**King's Mark  
Environmental  
Review  
Team  
Report**

**EAST GATE  
SUBDIVISION  
SOUTHINGTON  
CONNECTICUT**

Environmental Review Team Report

Prepared by the King's Mark Environmental Review Team  
of the King's Mark Resource Conservation  
and Development Area, Inc.

# PROPOSED SITE PLAN

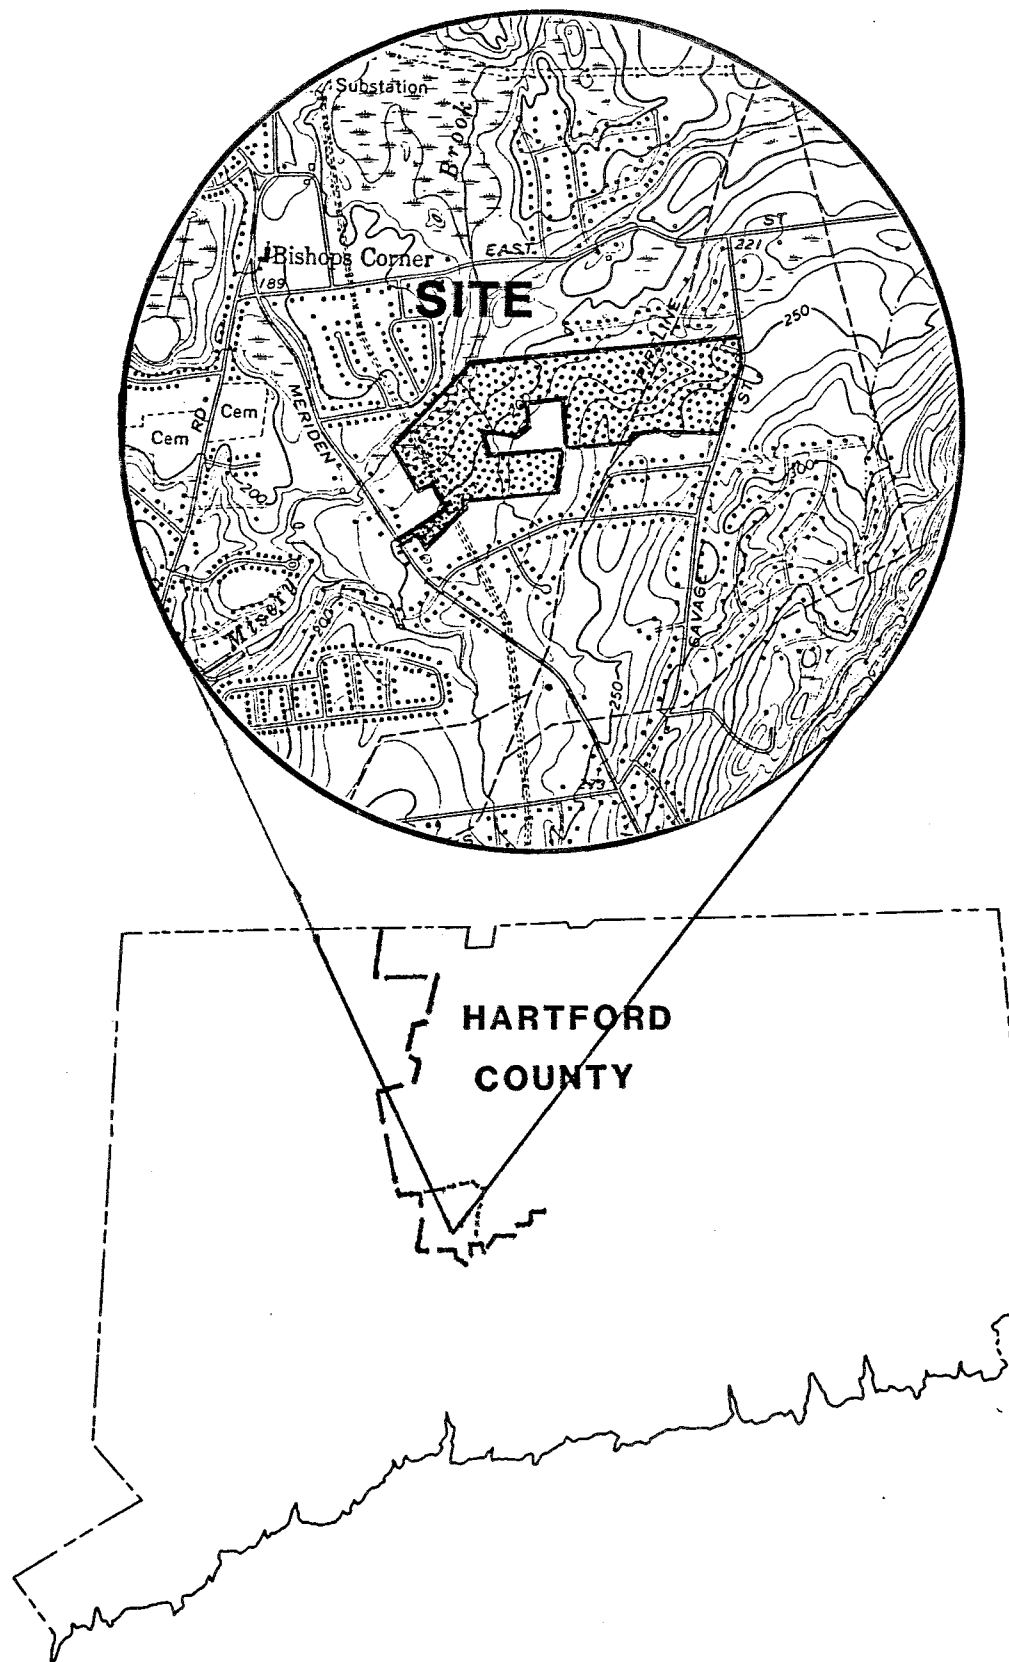
Based on the site plan distributed to Team members, approximately 1,110 feet of road will need to cross regulated wetland soils. This does not include driveway crossings. Although undesirable, wetland road crossings are feasible provided they are properly engineered. These roads need to be constructed adequately above the surface elevation of the wetland. This will permit better drainage of the road and also decrease the frost heaving potential. Road bed preparation needs to include removal of all organic material before the fill material is placed. In cut areas, underdrains should be installed on either side of the road. Road construction through wetlands should preferably be done during the dry time of the year, and should include provisions for effective erosion and sediment control. Culverts should be properly sized and located so as not to alter the water levels in the wetland or cause flooding problems.

The applicant's engineer should quantify the amount of fill to be placed over regulated soils and delineate the fill lines on the subdivision plan. This will also greatly help local decision makers during their review of the plan.

The proposed layout appears to show little respect for the obvious limitations of the land imposed by the substantial wetland areas. It is suggested that the Town of Southington consider adopting a minimum percentage in the lot area requirements of the zoning regulations. For example, the Town might require that lots contain no more than twenty-five percent of wetland soils before any fill of these wetlands is proposed. If this requirement were

### PROPOSED PHASE 1

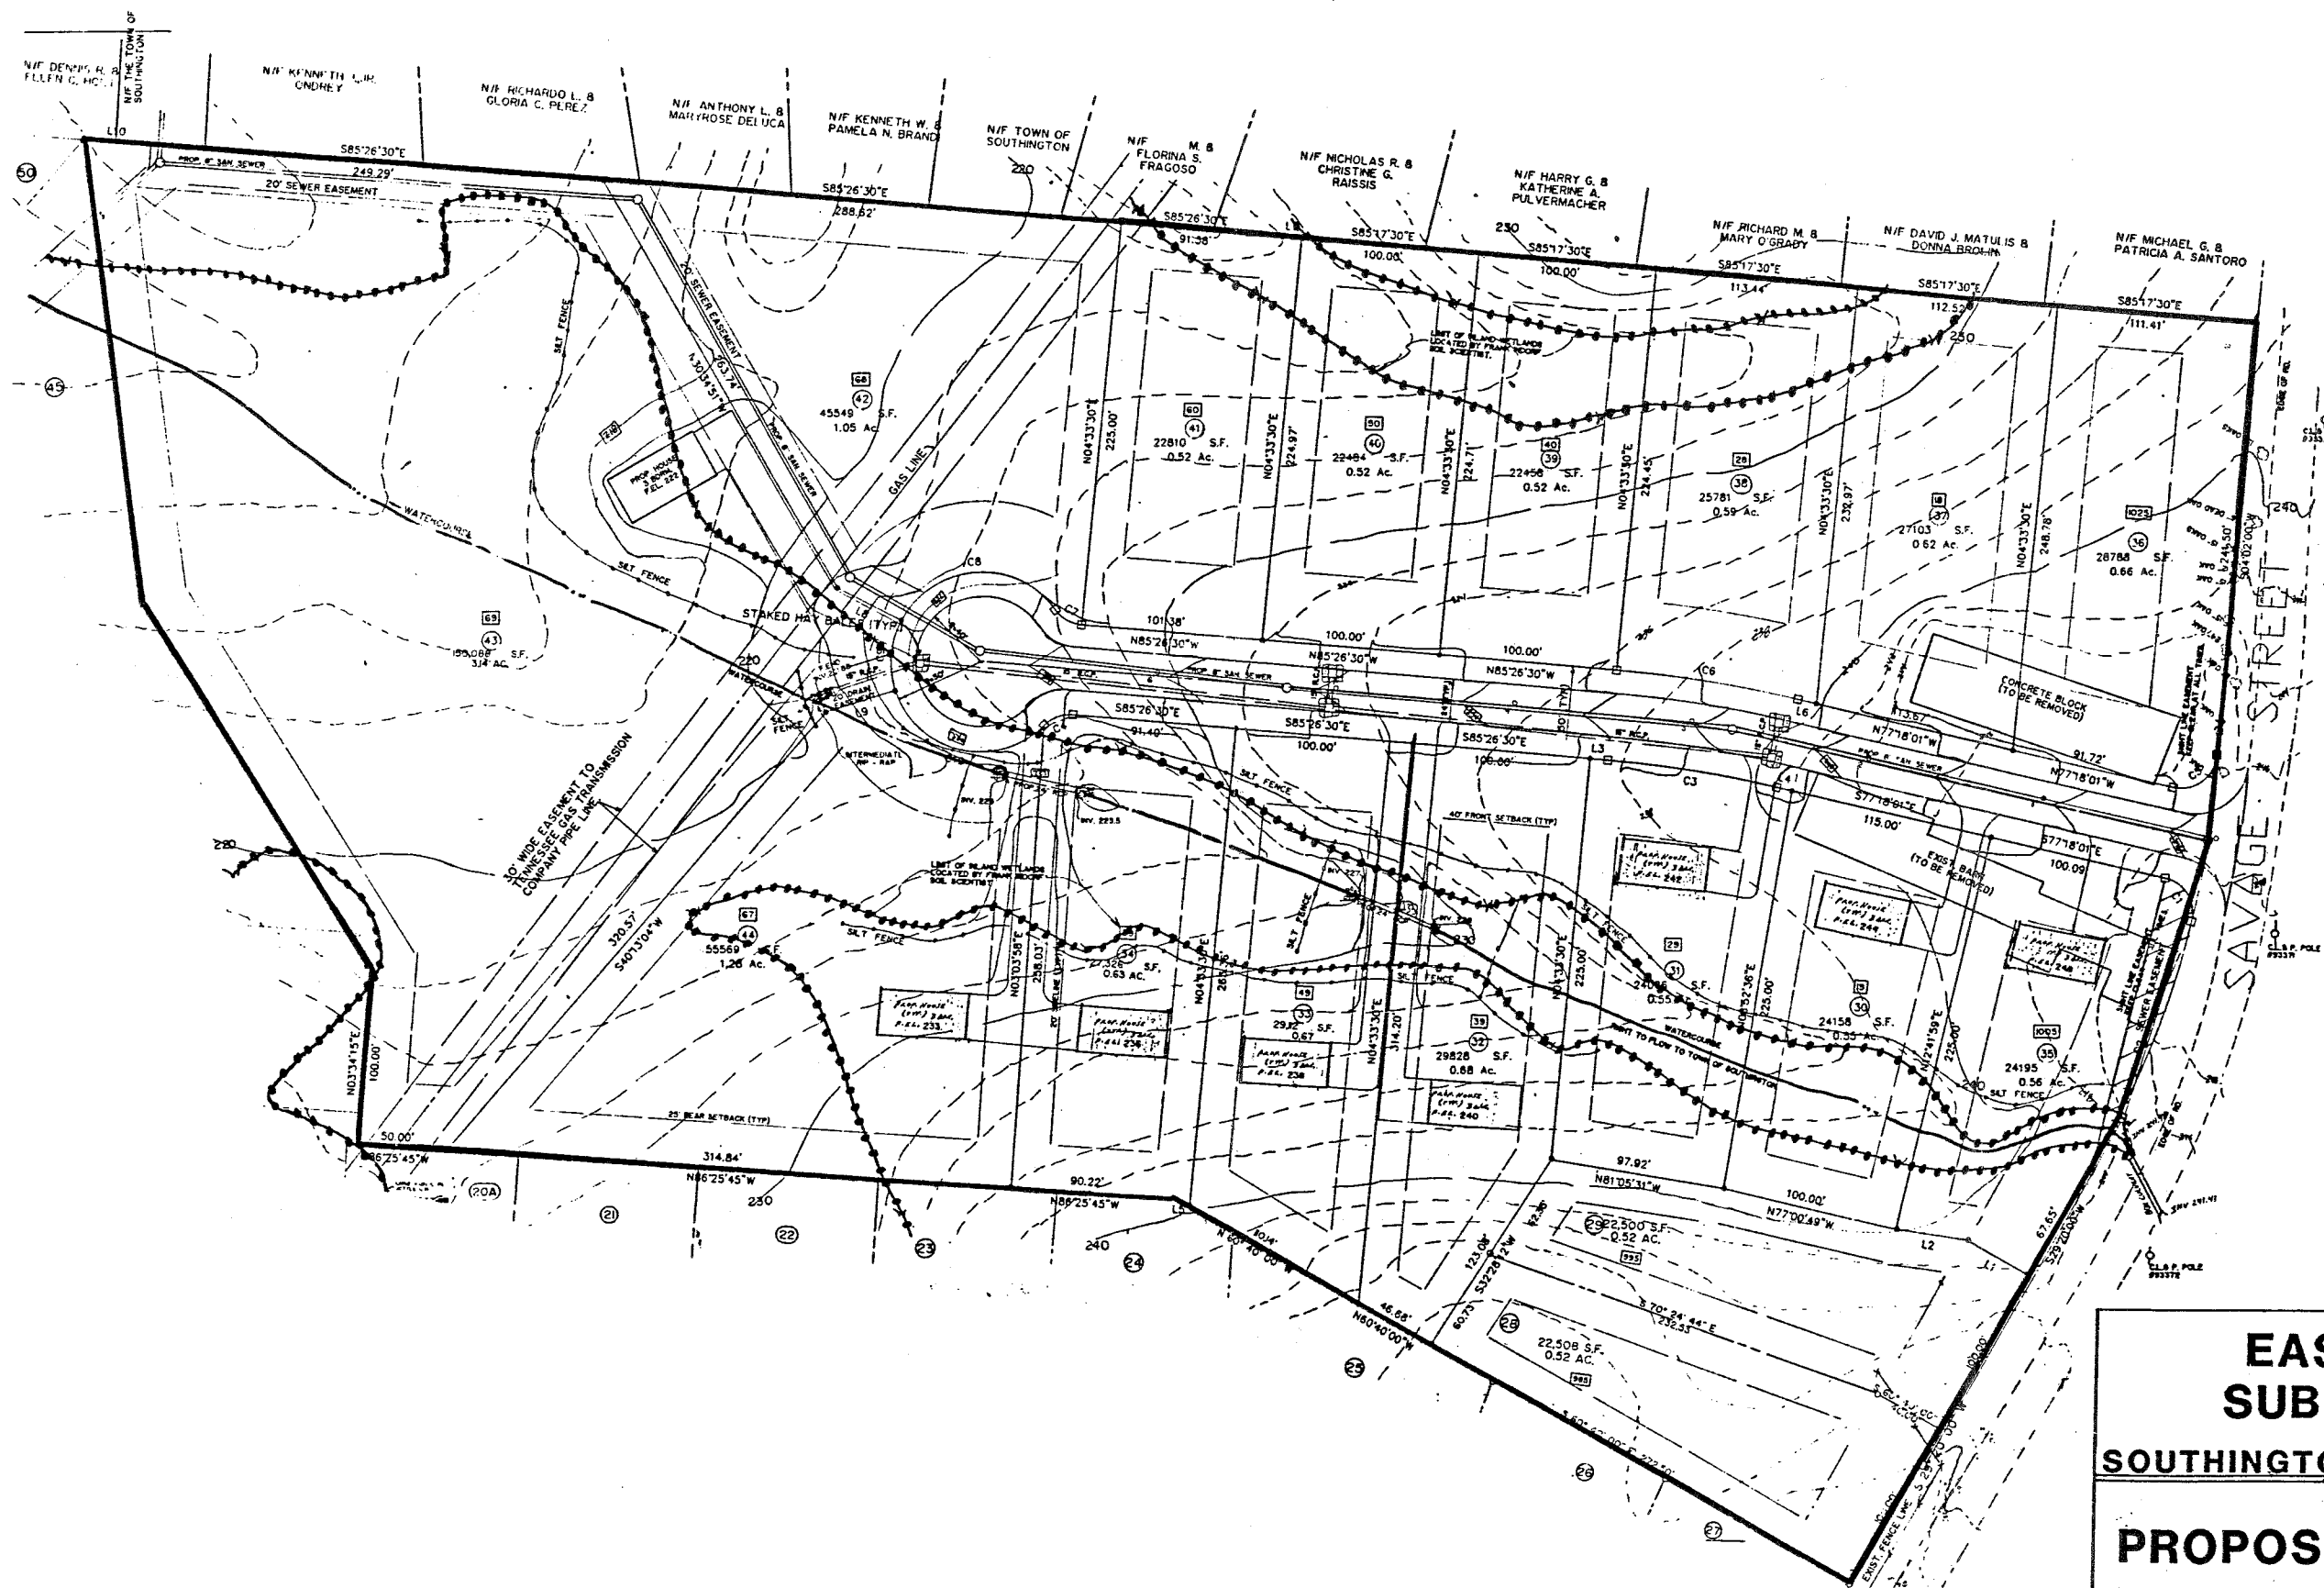
The inland wetlands along Lots 37 through 41 should be protected with a sediment barrier.

Additional soil erosion and sediment control measures that may be needed during Phase 1 include: (1) a construction entrance pad (showing location, details on plans and appropriate place within construction sequence); (2) improved catch basin protection by use of an "envelope" over and under the grate; (3) permanent and temporary seeding specifications; (4) mulching specifications; and (5) silt fence details.

Phase 1 Impacts: Phase 1 consists of a cul-de-sac which will access 17 building lots. As explained by the developer, these lots will be sold with deed restrictions preventing the land owner from performing any activities in within the wetlands without first notifying the local wetlands commission. Upon review, the commission may request the land owner to apply for a wetlands permit.

impacts from construction would be unavoidable. The last area of impact in this phase is the proposed detention basin in the northwest corner of the site. This would be created by the construction of a berm, designed to control runoff from a 100-year storm event, and would be created within an existing wetland area. Construction of this basin will result in some direct fill of wetlands and potentially change the vegetative quality of the surrounding wetland area.

- (1) In phase one the use of box culverts for the crossing is highly preferable so as to limit long-term disturbance to the habit corridor. Box culverts with natural bottoms would provide a less intimidating barrier to the movement of small mammals and invertebrates. Crossings of this type would also have less impact on the isolated portion of the wetland by maintaining natural water flow rates and allowing the wetland to perform natural flushing of sediment and debris during storm events without any ponding of water. If ponding were to occur because of the use of smaller culverts this could alter the natural character of the corridor and would result in increased sediment and debris accumulation.

Phase 1 of the proposed subdivision will directly impact an unnamed tributary stream to Misery Brook. The stream is planned to be crossed by two driveways with flows being passed underneath through culverts.
